## NORTH VALLEY LANDFILL CELL 1 LINER INSTALLATION – ADDENDUM 1

May 8, 2017

BID SCHEDULE      Updates to Bid Items 4, 5, 9, and 10

DRAWINGS            Updates to Sheet 2 and Sheet 5

DT-10 LINER TERMINATION IN SLOPE OR FLOOR  
5

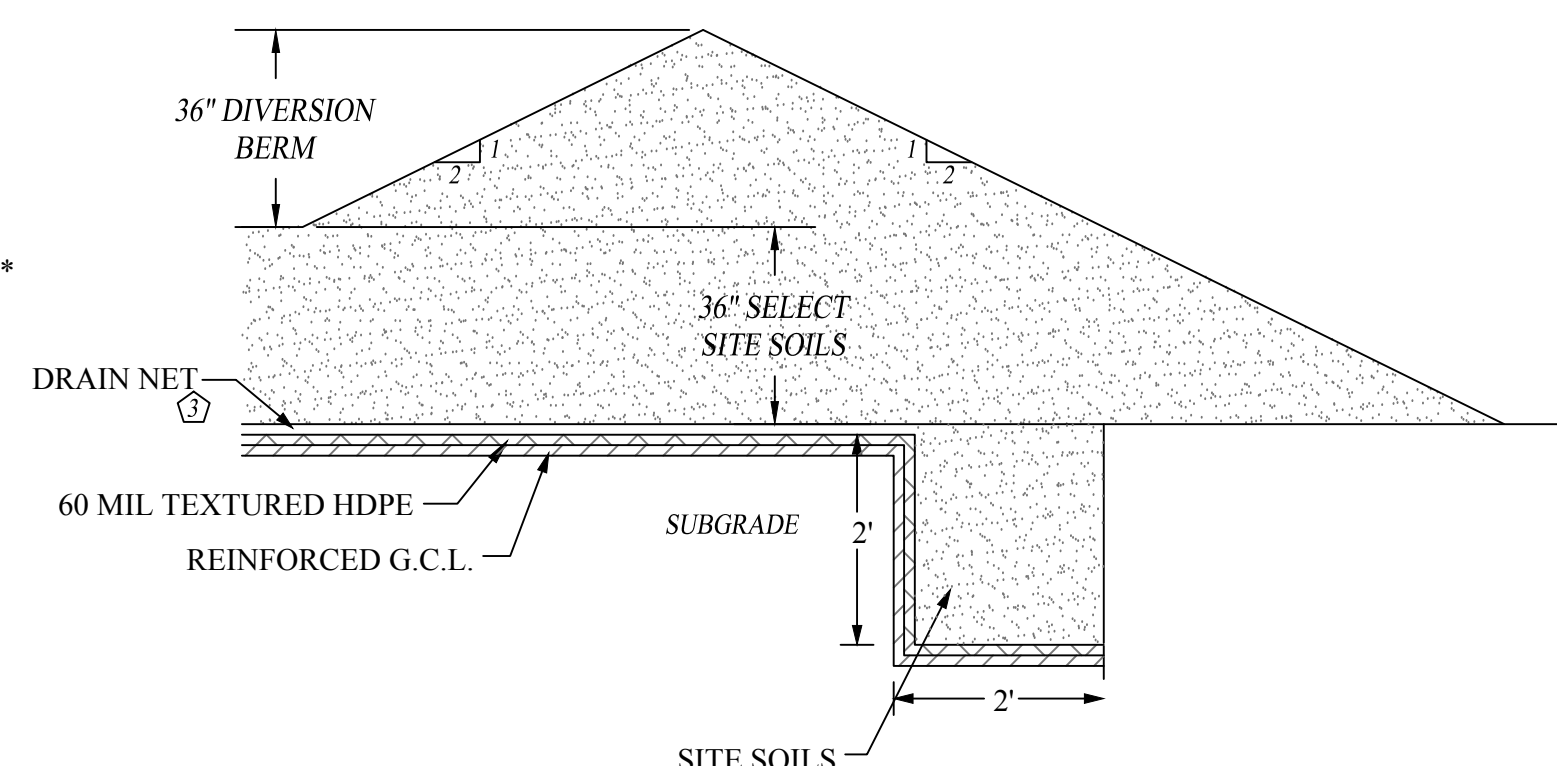
\* Includes slope stockpile and liner termination berm on slope or floor (DT-10)
